Dedicated Fuel Pickup Line

SD-1001

Evolution Aircraft, Inc

September 1, 2021

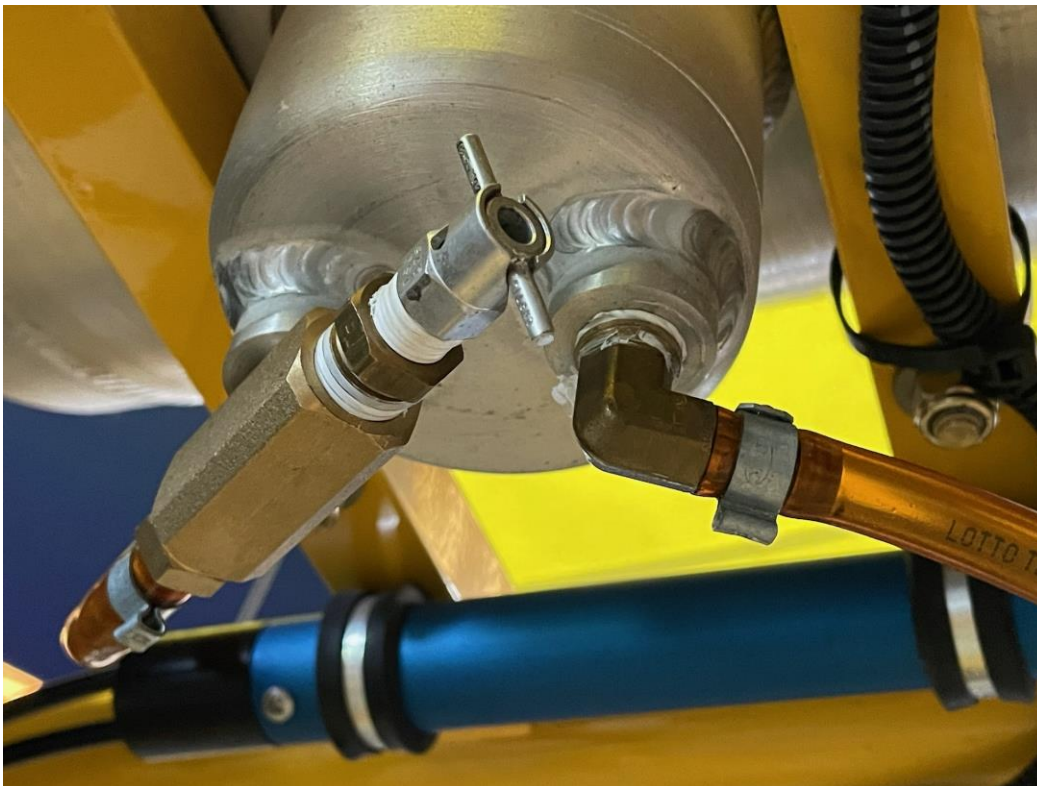
It is possible to introduce air into the fuel supply line when the gas tank gets low on fuel. It has been determined that the fuel supply line to the carburetor must be independent of the sight gauge fuel line.

- Empty fuel tank.
- Remove fuel supply line and fuel vent line from existing T fitting. To remove Oetiker clamps use a small flathead screwdriver to pry open tab on backside of clamp.
- Remove Curtis Quick drain and 1/4" fuel line fitting from fuel tank.
- Teflon tape all threads and install supplied T into front gas tank threaded bung.
- Install 1/4" threaded barb into supplied T aiming at site gauge/ fuel line and connect sight gauge using hose clamp.
- Install Curtis Quick drain to the other side of the T. The drain will now remain sideways.
- Reinstall original 90° 1/4" barb into rear threaded bung in gas tank and connect fuel supply line with hose clamp.
